NOTICE TO ALL FIRMS

From: Sam Li
Deputy Director of Purchasing

Re: Addendum Number 1
IFB # C1584 – Kaufman Res. Hall Corridor Carpet and Full Floor Cove Base
Replacement Floors 8-11

1
A-800
TYPICAL FINISH FLOOR PLAN - FLOORS 8-9
SCALE: 3/32" = 1'-0"

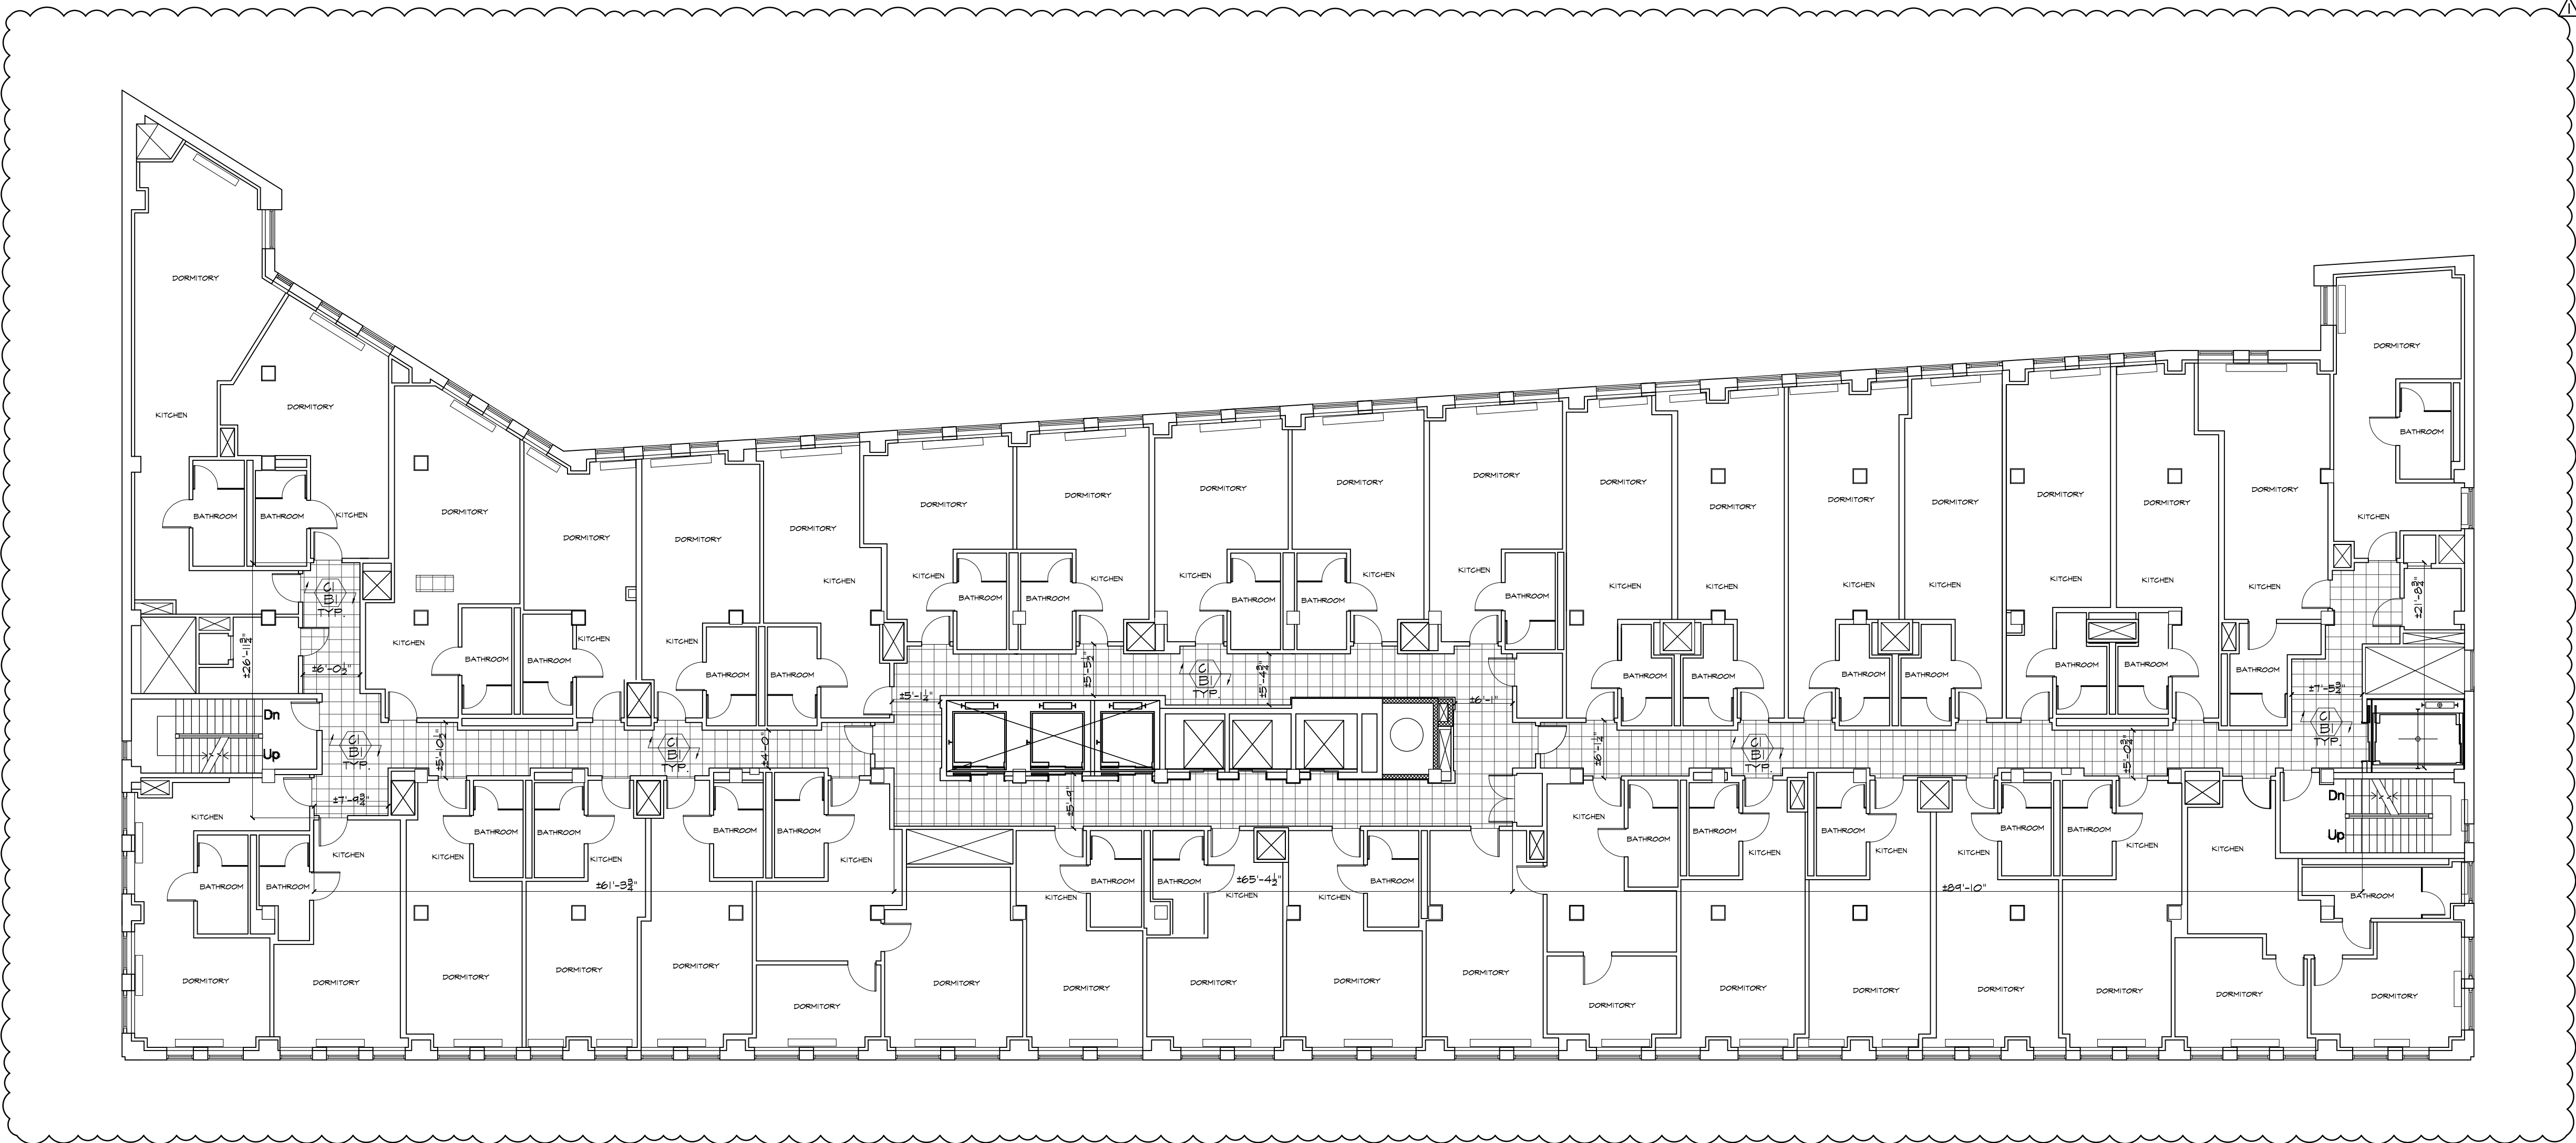
- Q1. Is there a copy of the full floor plan for Floors 8, 9, 10, and 11? Pages A-800, A-801, and A-802 all show the north side completely but seem to be cutting off the south side of the building. I want to be sure of the cove base quantities needed.
- A1. Please see the attached drawings. We have revised the scale, so you now can see the full floors.
